Appendix F Responses to Comments

Responses to Comments: Agencies

Subject: State Route 1 Centerline Rumble Strips Project (04-4G780), Initial Study/Negative Declaration, SCH No. 2023010380, Sonoma County

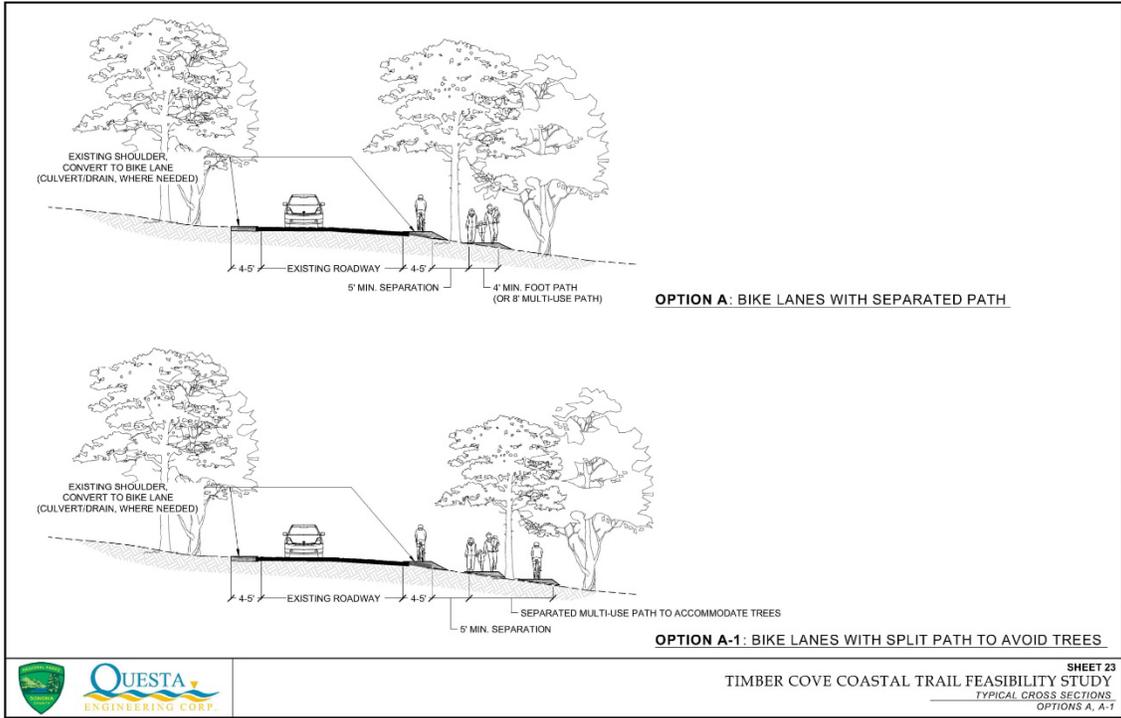
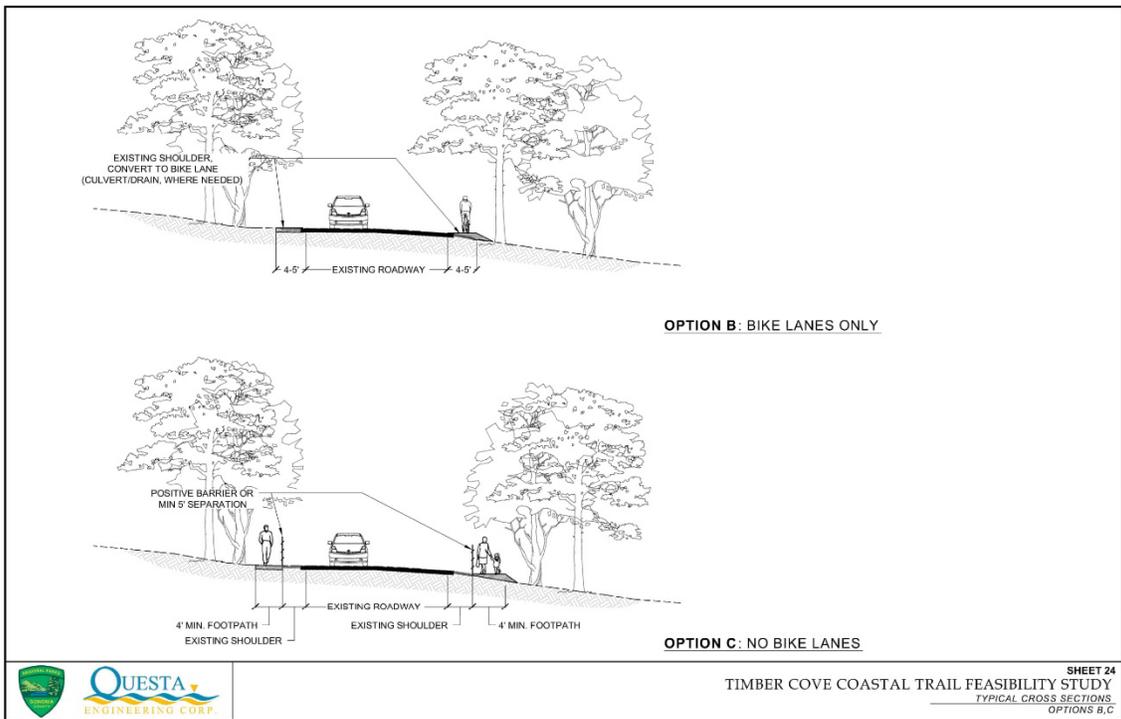
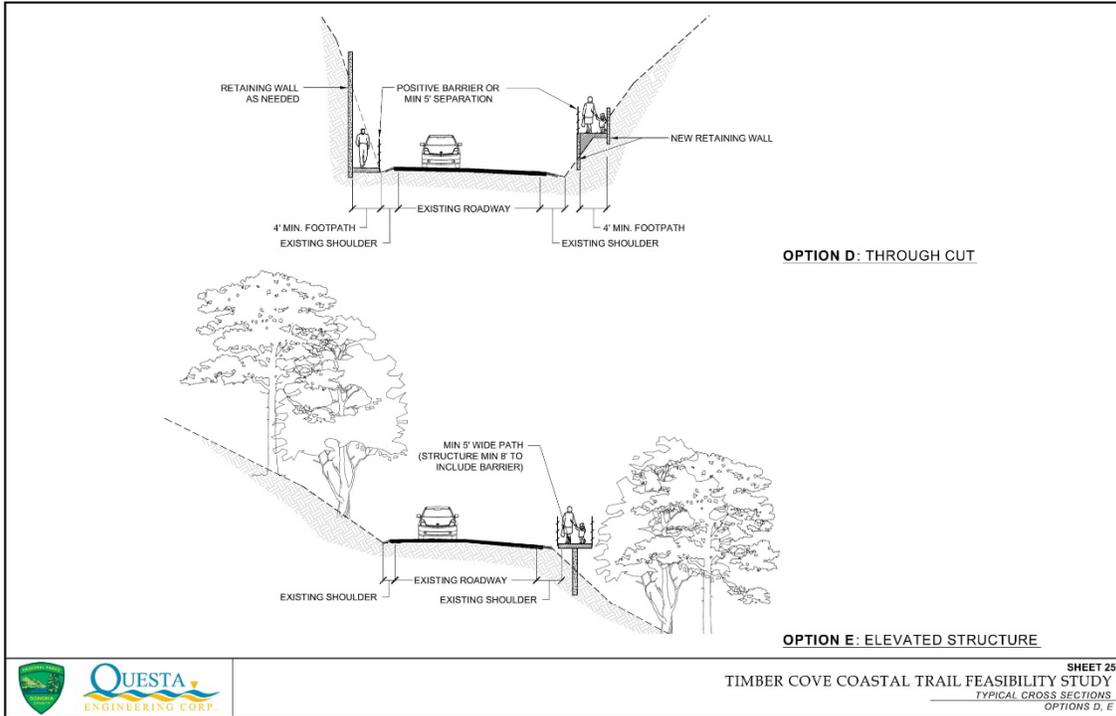
Regional Parks is working on the development of several sections of the California Coastal Trail which will also provide a safe pathway for bicyclists and pedestrians along the State Route 1 corridor. The specific Coastal Trail sections are identified in the subsequent paragraphs.

Regional Parks is planning to advertise for construction bids for the North Coast Trails project in winter 2023 and completing trail construction in 2025. It is our understanding that Caltrans plans to start construction of the centerline rumble strip and shoulder pavement widening in January 2025. As Caltrans gets closer to finalizing the project schedule, please contact Regional Parks so that we can 1) review and provide input on the Caltrans improvement plans and 2) coordinate our construction activities.
